**WCAP-16996-P, "Realistic LOCA Evaluation Methodology Applied to the Full Spectrum of
Break Sizes (FULL SPECTRUM LOCA Methodology)"
Requests for Additional Information – Third Set (Non-Proprietary)**

May 2013

RAI #30 – Scaling of the Westinghouse Vertical COSI Test Facility and Tests

Figure 5. Measured Intact loop (Loop A) steam flow rate in ROSA SB-CL-05. (Reference [2]).

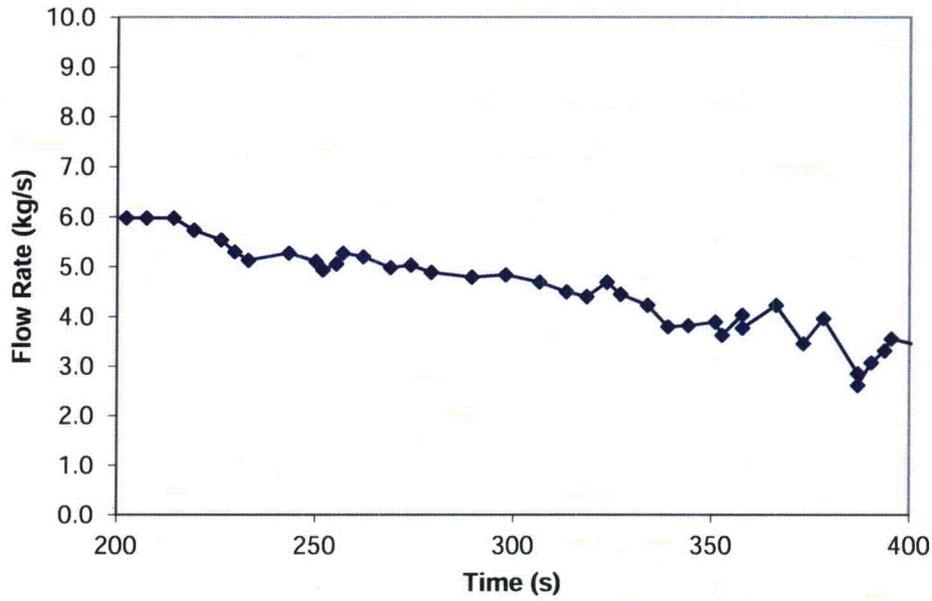
- (2) ROSA-IV LSTF Test SB-CL-05 was used as a separate effects test for cold leg SI condensation by modeling only the cold leg and SI injection portion in ROSA-IV and using test measurements of instantaneous flow conditions in the cold leg at four selected instances []^{a,c} Please explain which of the flow parameters in Table 17-7, "ROSA SB-CL-05 SI Condensation Test Data for separate effects tests (SETs)," were measured and how the provided experimental values were established and qualified. For example, test measurements can exhibit noticeable oscillations in time. For all remaining parameters in Table 17-7, if any, please provide the expressions used for their calculation.

(2) The ROSA SB-CL-05 experiment is an integral effects test featuring high head safety injection toward the cold leg. Unlike the COSI experiment, there was no steady state in the cold leg during the ROSA test. However, it is found that the cold leg flow condition in the boil off stage of SB-CL-05 is stable and the transient is slow. [

The ROSA SB-CL-05 data reduction process included the use of raw data, establishing data points and converting test data to condensation heat transfer rates. First, the measured pressure transient of the experiment was used. [
